From: Michael Eastham
Sent: 13 February 2018 14:38
To: Planning.Responses
Subject: LU/398/17/DOC

**Reserved Matters Application (Phase 2)
and Discharge of Conditions,
North Littlehampton**

Noise Assessment

February 2018

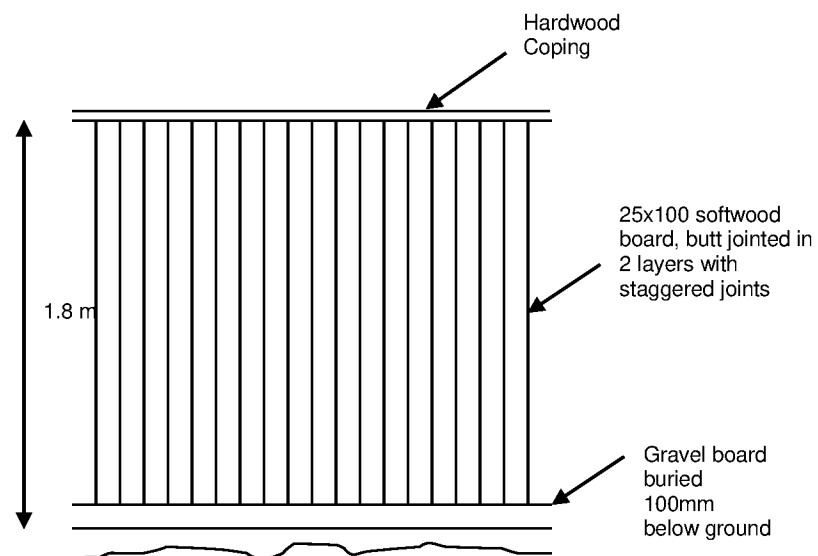
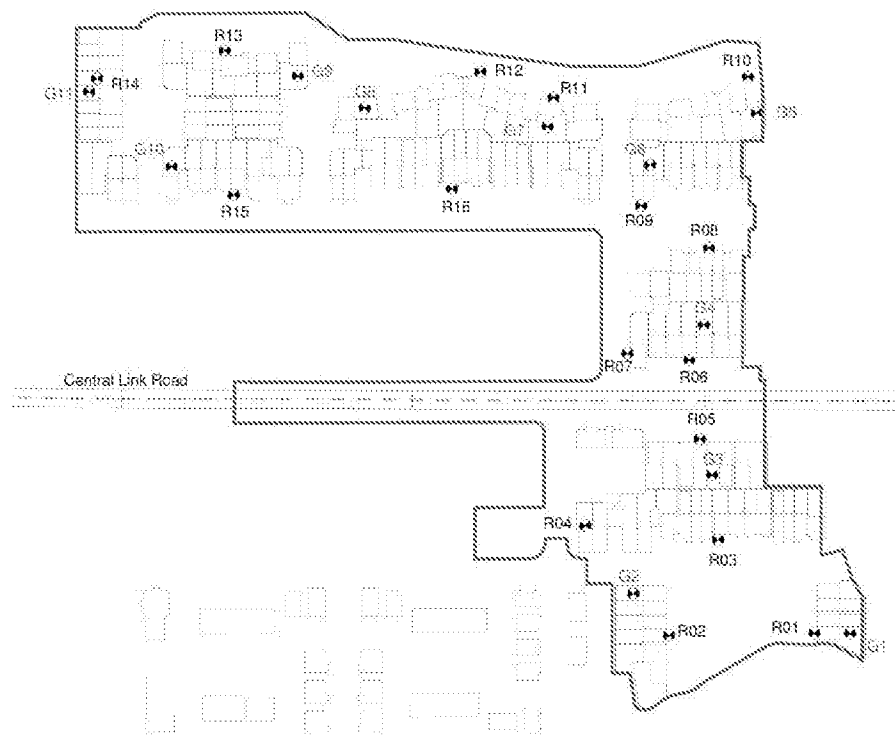
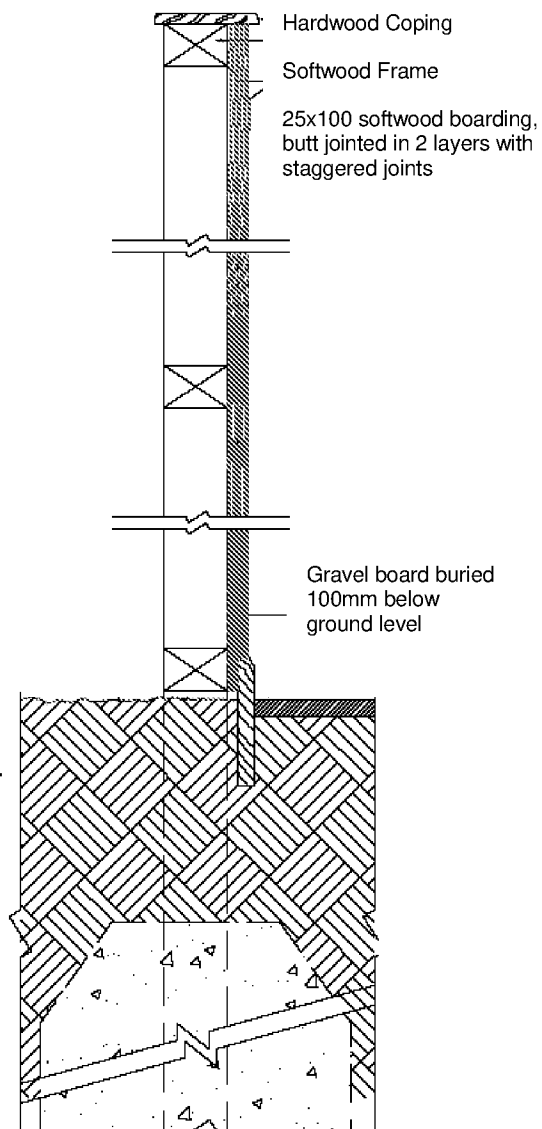
ADC Comment 3

'Building Design and Layout' Please provide the agreed layout of buildings and position of noise sensitive rooms within these in relation to the main sources of noise ie roads, in order to demonstrate the way in which building orientation and internal arrangement have been design to reduce external noise impact.

Considered in Section 6 above.
